BURLINGTON DEVELOPMENT REVIEW BOARD

Tuesday August 20th, 2019, 5:00 PM

- 2. 20-0037CA/MA; 266 College Street (FD5, Ward 8E) Hotel Y Burlington, LLC**
Building renovations and addition for hotel, below grade parking structure, and rooftop bar and restaurant.

SHEET TITLE:
GARAGE LIGHTING PHOTOMETRIC PLAN

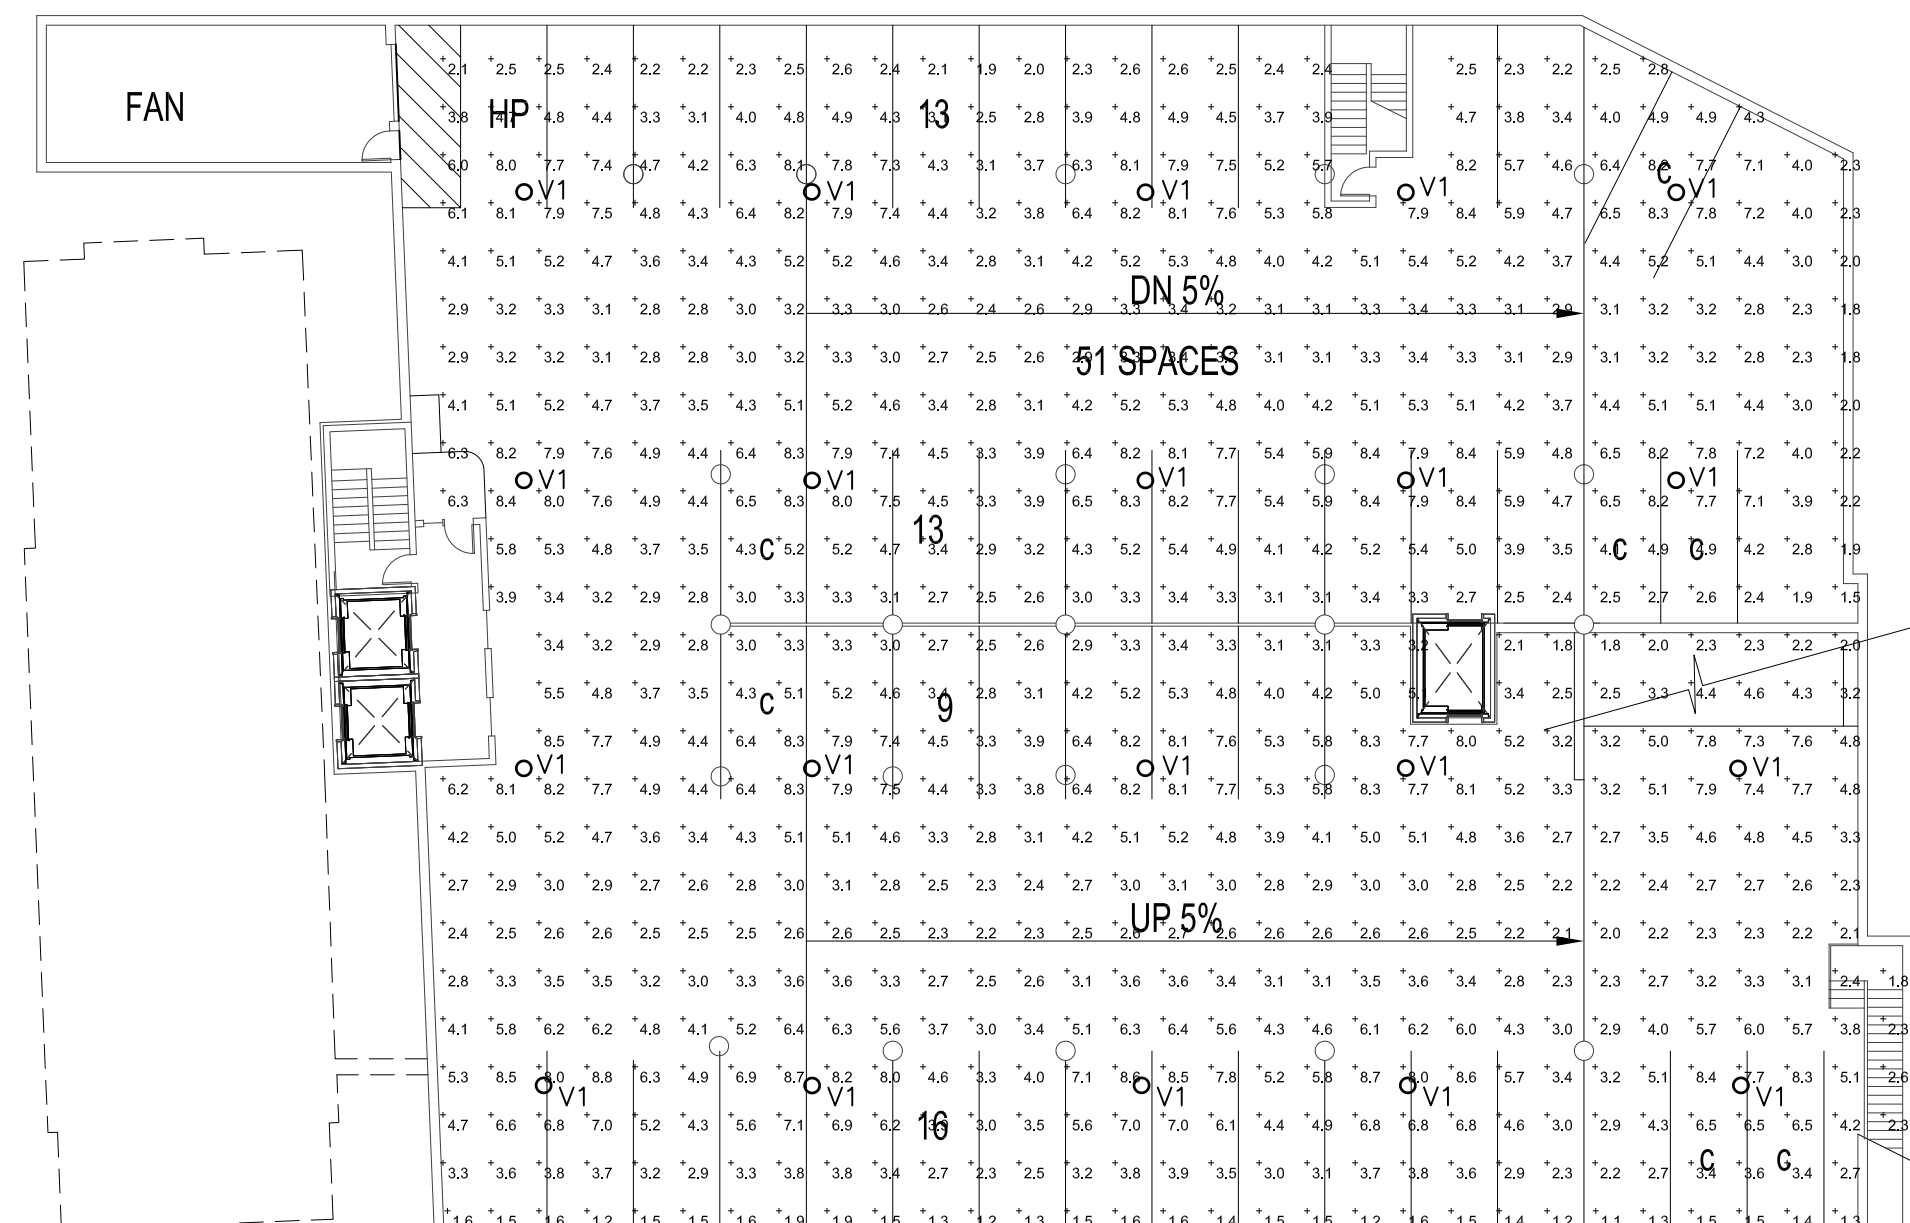
Illuminance for the parking garage as provided is generally higher than recommended by IESNA RP-20-98. Parking floors are expected to have an overall illuminance of 5 fc (8-9 provided), with a 10:1 max/min horizontal uniformity ratio. Similarly, the entrance ramp should not exceed 50 fc (52.4 provided) as a transition from daylight to the interior of the facility. A revised photometric for the garage lighting shall be provided to reflect these standards, or any current standards of IESNA or similar. **Affirmative finding as conditioned.**

11. **Prior to release of the zoning permit**, a revised photometric plan for the garage lighting shall be provided to reflect adjusted light measurements consistent with IESNA RP-20-98, or current edition of IESNA or similar lighting manual.
